CITY OF NOVI CITY COUNCIL
OCTOBER 26, 2026

SUBJECT: Consideration of final approval of Zoning Map Amendment and Planned Rezoning Overlay (PRO) Agreement for the Novi-Ten Development.

SUBMITTING DEPARTMENT: Community Development Department - Planning

Attachment A
Site Photographs

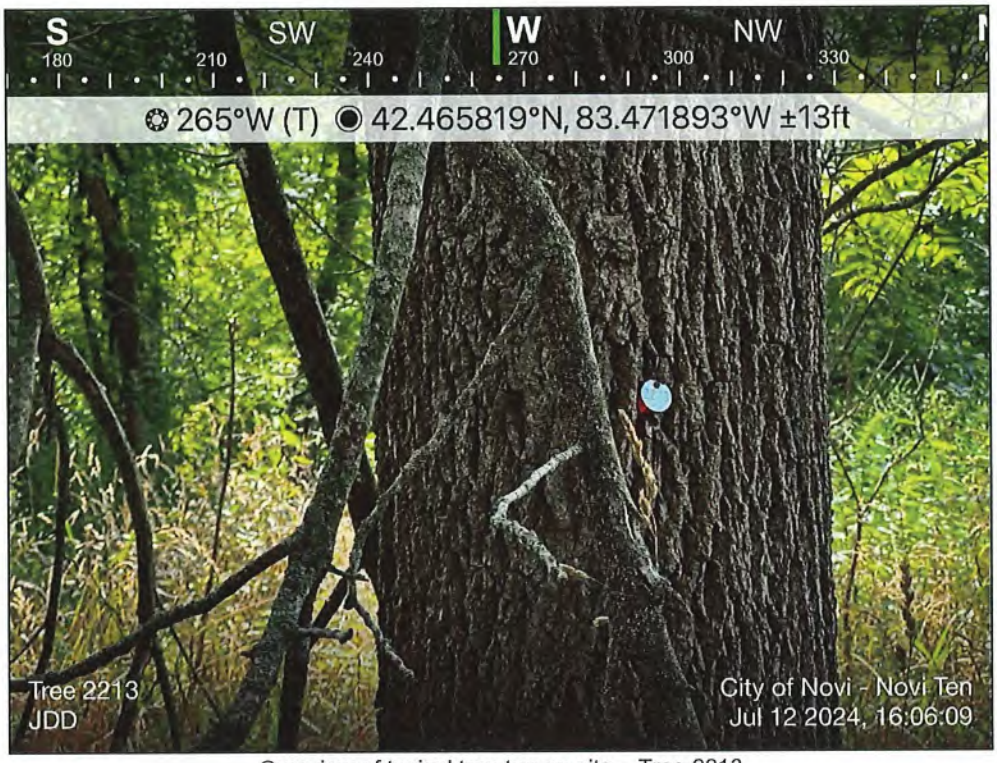
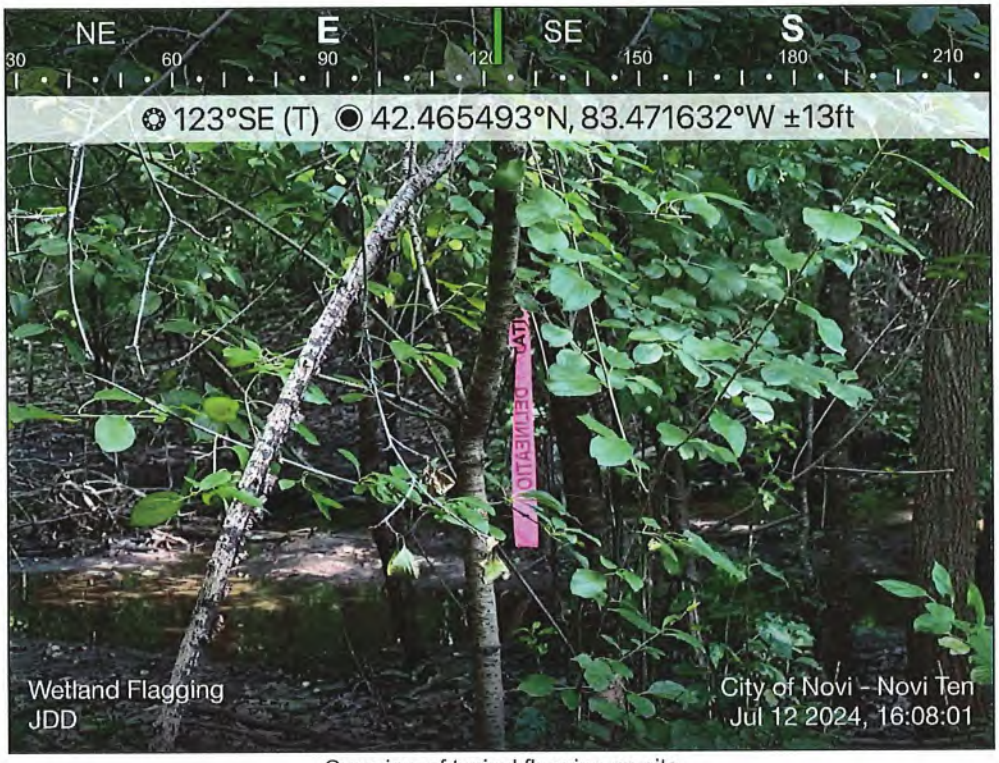
1. City-regulated woodlands, as identified on the City of Novi Woodlands interactive map website, are present onsite. **Note that both the woodlands and property limits depicted on the City map are considered approximations (Figure 1).** Pursuant to Section 37-2 and Section 37-4 of Chapter 37, Woodlands Protection, woodland areas can be identified by additional features such as soil quality, habitat quality, tree species and diversity, health and vigor of tree stand, understory species and quality, presence of wildlife, and other factors such as the value of the woodland area as a scenic asset, wind block, noise buffer, healthy environment, and the value of historic or specimen trees. A site visit was performed on July 12, 2024 to verify and review the extent of woodlands on-site. Merjent has determined that all of the trees on-site should be considered regulated woodland due to the stand density and connectivity to other larger regulated woodland areas. Select photos from the site visit are included in **Attachment A**.
